DRAWING NO. D212-664-141	TITLE XTUBE ASSY (205/212/412 HI FWD)	REV. D	DART AEROSPACE LTD ENGINEERING ORDER		D.E.O. NO. D212-664-141-D-1	SHEET NO. SHEET 1 OF 2	SCALE NTS
DRAWN	CHECKED	UP	MFG. APPR.	APPROVED	DE APPR.		
DATE 11.04.07	DATE 11.04.11		DATE 11.04.12	DATE 11/04/12	DATE 11.04.12

ADD AN INSPECTION WINDOW TO UNDERSIDE OF CROSSTUBE.

DRAWING NO. D212-664-141	TITLE CROSSTUBE ASS'Y (205 HI FWD)	REV. D	DART AEROSPACE LTD ENGINEERING ORDER		D.E.O. NO. D212-664-141-D-2	SHEET NO. SHEET 1 OF 1	SCALE NTS
DRAWN <i>UP</i>	CHECKED <i>ASS</i>	MFG. APPR. <i>AS</i>	APPROVED <i>MD</i>		DE APPR. <i>HH</i>		
DATE 11.07.15	DATE 11.07.20	DATE 11.07.21	DATE 11/07/21		DATE 11.07.21

ADD NEW CONFIGURATION WITH ANODIZED FINISH

**D212-664-141/-141B
ASSEMBLY DETAIL**

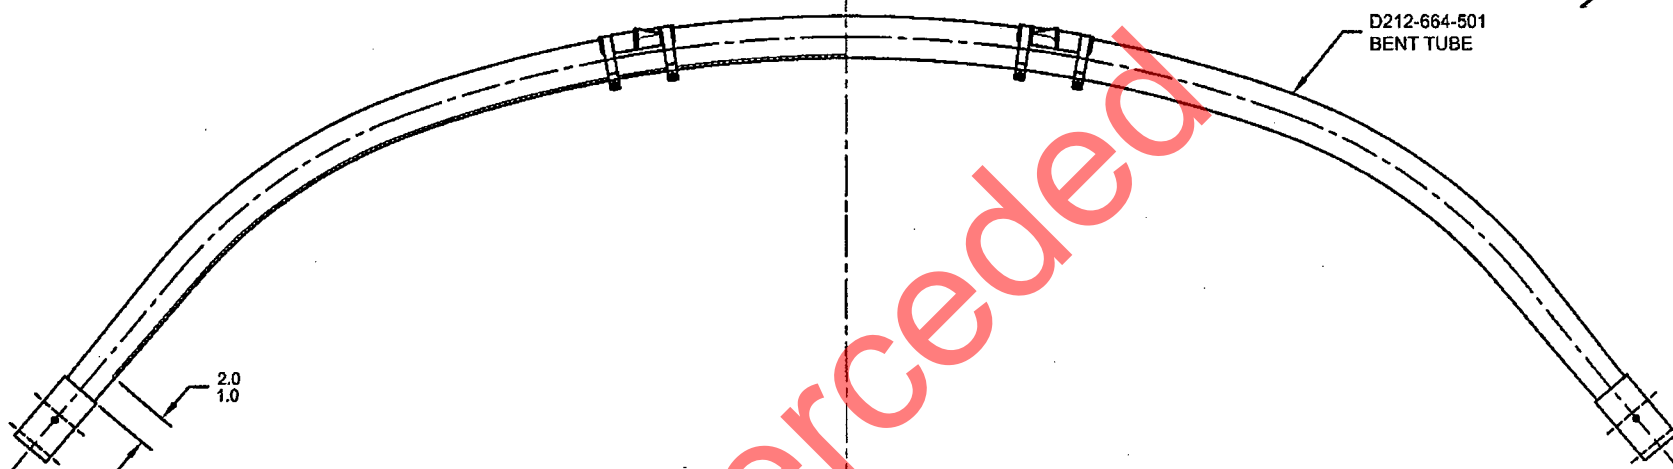
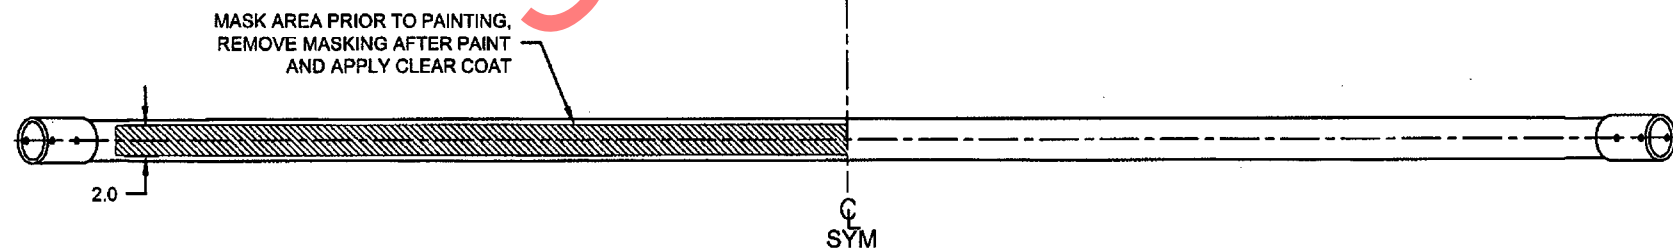
NOTES 2 OF SHEET 1 IS AMENDED AS FOLLOWS:

- 2) FINISH: CHEMICAL CONVERSION COAT PER DART QSI 005 4.1
PRIME INSIDE AND OUTSIDE PER DART QSI 005 4.2
MASK UNDERSIDE OF CROSSTUBE AS SHOWN (HATCHED AREA) AND
PAINT OUTSIDE PER DART QSI 005 4.2
REMOVE MASKING AND APPLY CLEAR COAT
